Re: Submittal of Response to Comments and Addendum to
Tyrone Stage 1 Abatement Plan Proposal, DP-1341 Condition 34

Addendum to the Tyrone Mine Facility Stage 1 Abatement Plan Proposal

**Response to June 2006 NMED Comments
Stage 1 Abatement Plan Proposal
DP-1341, Condition 34
Phelps Dodge Tyrone, Inc.**

Figure 13

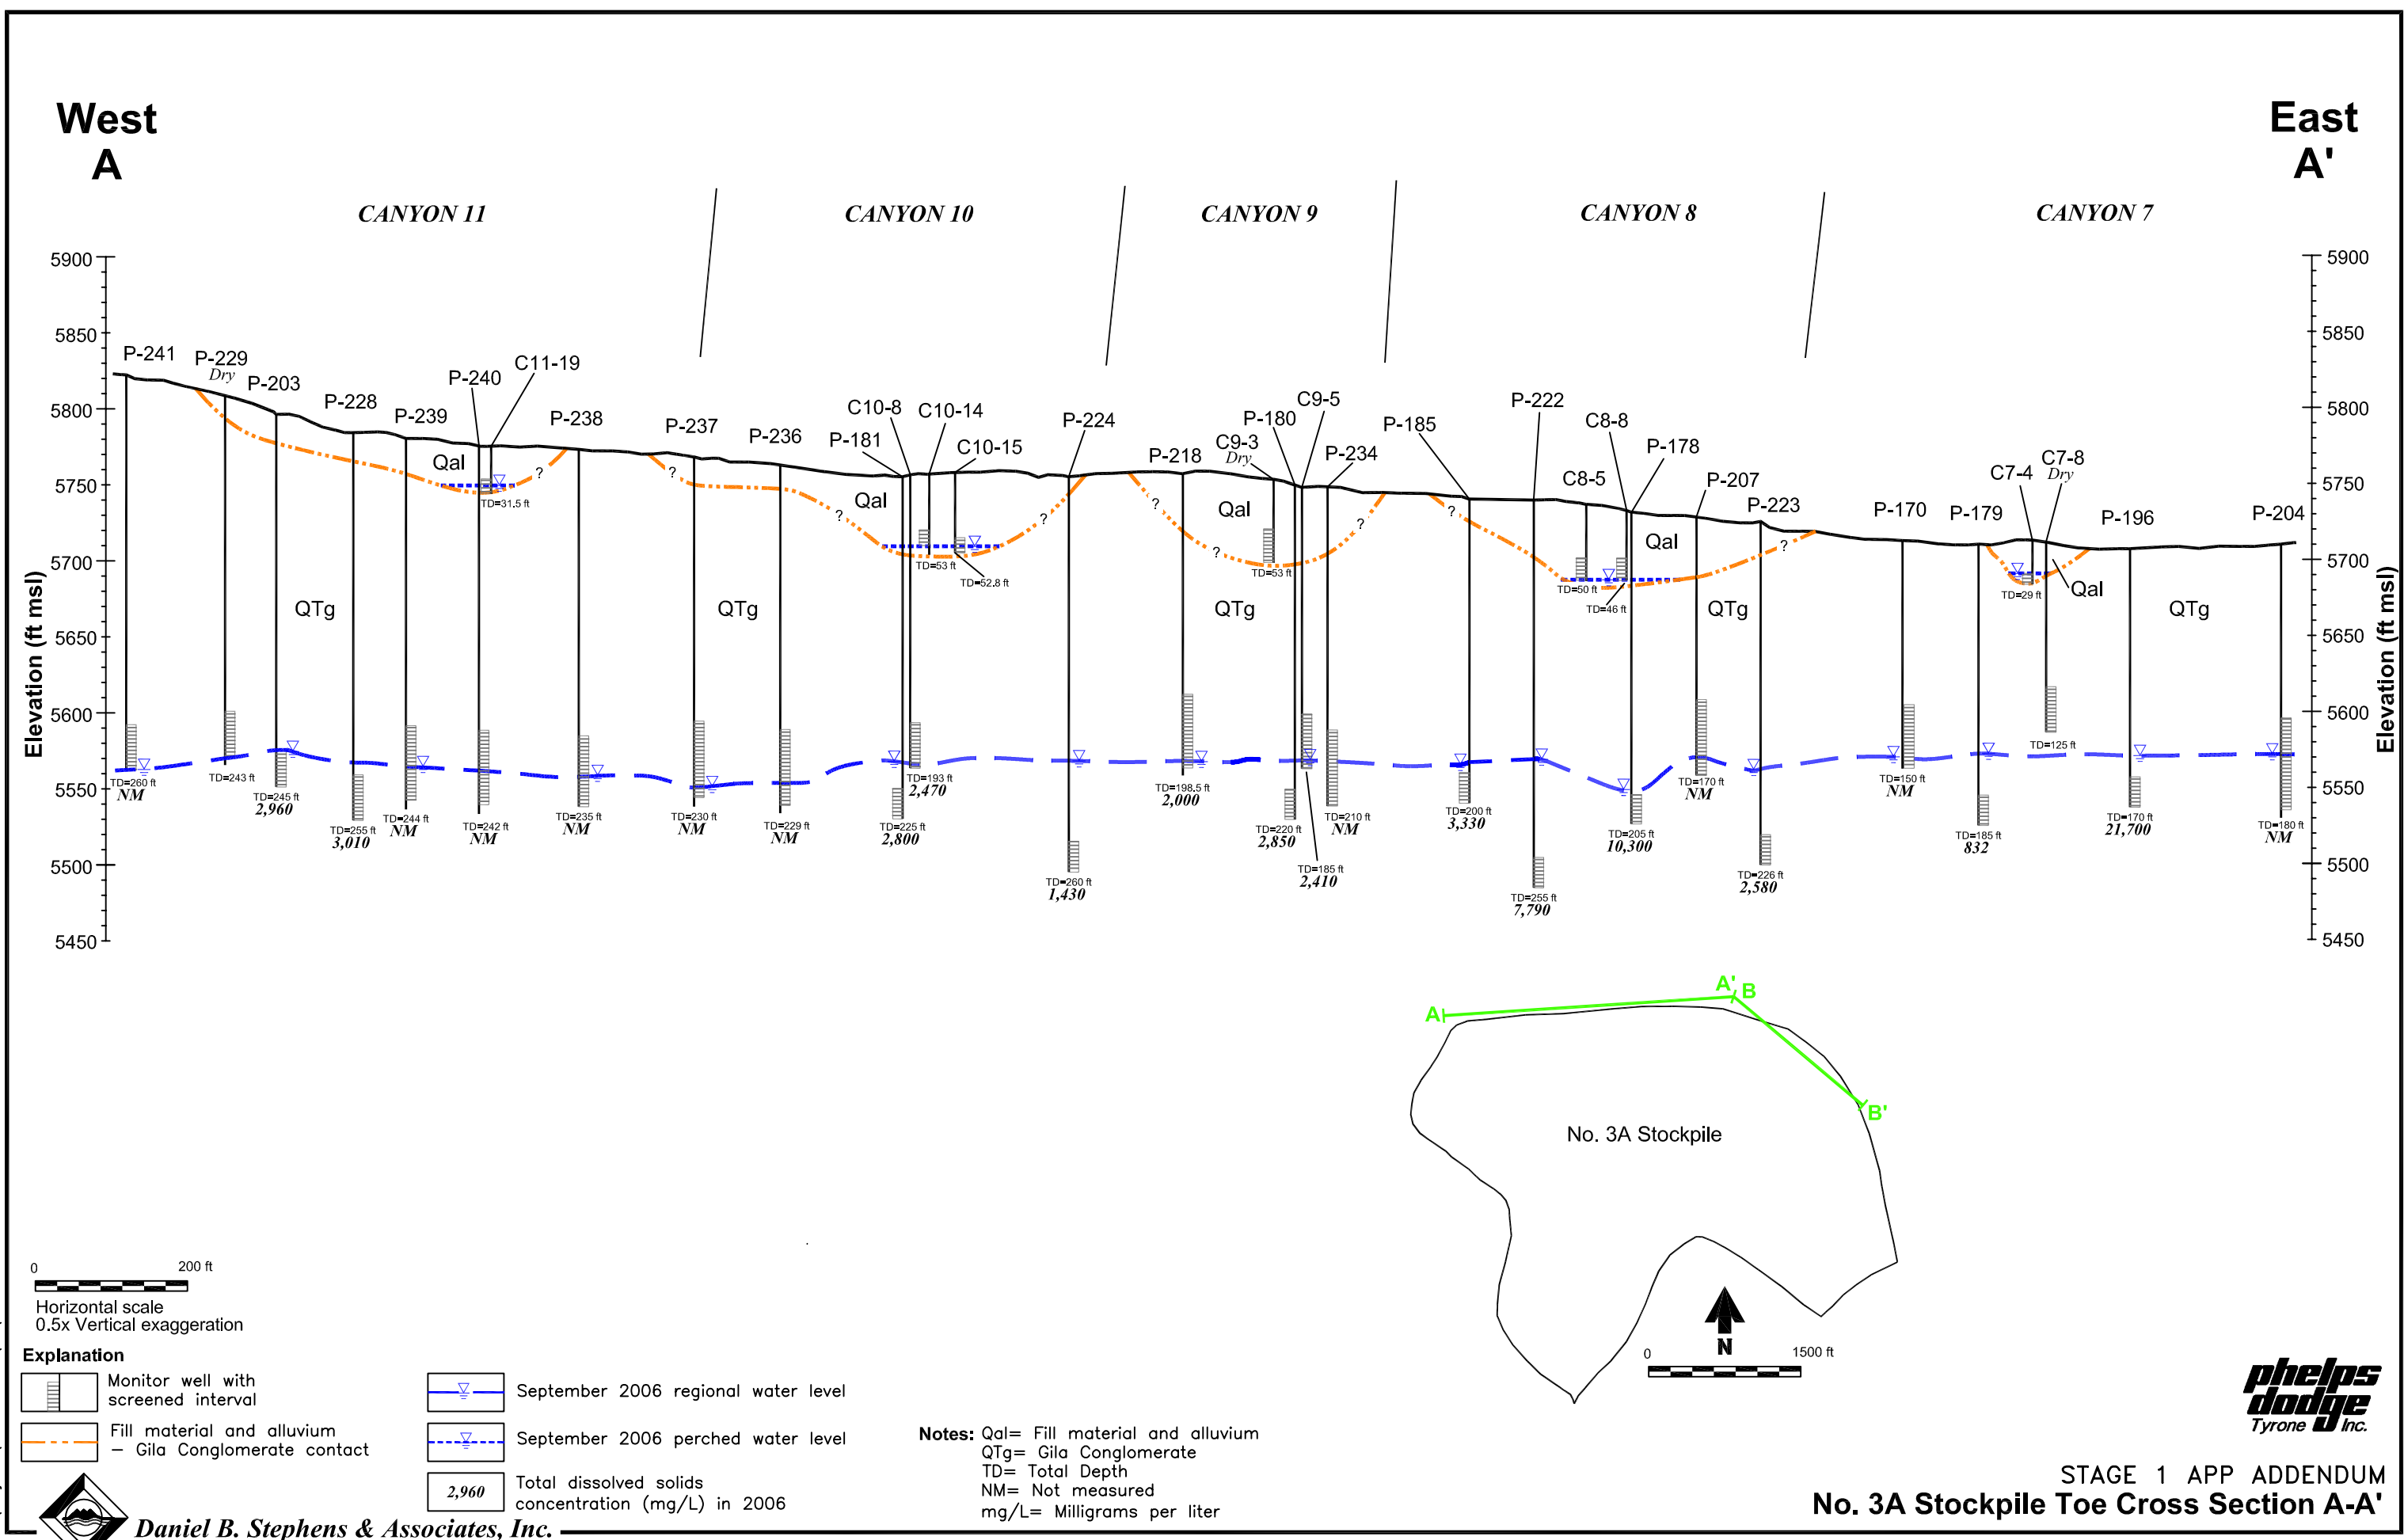
Two additional regional monitoring wells are proposed for the western portion of the No. 3 Leach Stockpile. As stated in Comment 18, the rapid increase in contaminant concentrations warrants a more extensive investigation including an assessment of deeper pathways within the regional aquifer. More wells may be required depending on the outcome of the investigation. Geological cross-sections may be useful when evaluating the vertical extent of contamination.

20. Section 3.3, Page 44. Not all streams at the Tyrone Mine are ephemeral. The stream in Deadman Canyon is perennial.
21. Section 3.4, Page 48. Two additional regional monitoring wells are proposed for the western portion of the No. 3 Leach Stockpile. As stated in Comment 18, the rapid increase in contaminant concentrations warrants a more extensive investigation including an assessment of deeper pathways within the regional aquifer. More wells may be required depending on the outcome of the investigation. Geological cross-sections may be useful when evaluating the vertical extent of contamination.

Figure 13 is a cross section along the toe of the No. 3A stockpile from Canyon 11 to Canyon 7, and Figure 14 is a cross section from Canyon 6 to Canyon 4. These figures show perched and regional wells with screened intervals, the vertical and horizontal extent of perched water in the canyons, the regional water table, and TDS concentration at regional wells where available. At some locations, higher TDS concentrations are found in shallower wells screened near the top of the regional water table and beneath the perched seepage zones, suggesting vertical migration of contaminants from the perched seepage zones to the regional aquifer. This observation is consistent with previous investigation findings at the No. 3A stockpile that indicate regional seepage pathways are spatially related to the natural drainages beneath the stockpile. The result of this seepage has been a progressive degradation in water quality along the toe of the stockpile from the Canyon 4 through the Canyon 11 areas.

At other locations, however, monitor wells with deeper well screens actually have higher TDS concentrations than nearby wells with shallower well screens (e.g., wells C9-5 and P-180 at Canyon 9 in Figure 13). At these and potentially at other locations, it is possible that some of the impacts to the regional aquifer are attributable to the lateral migration of contaminants from beneath the stockpile footprint, as opposed to downward seepage of pregnant leach solution or impacted water from overlying alluvium-filled drainages. This type of flow path would be a longer, and likely a slower, flow path for impacted water as opposed to seepage from beneath the alluvial channels.
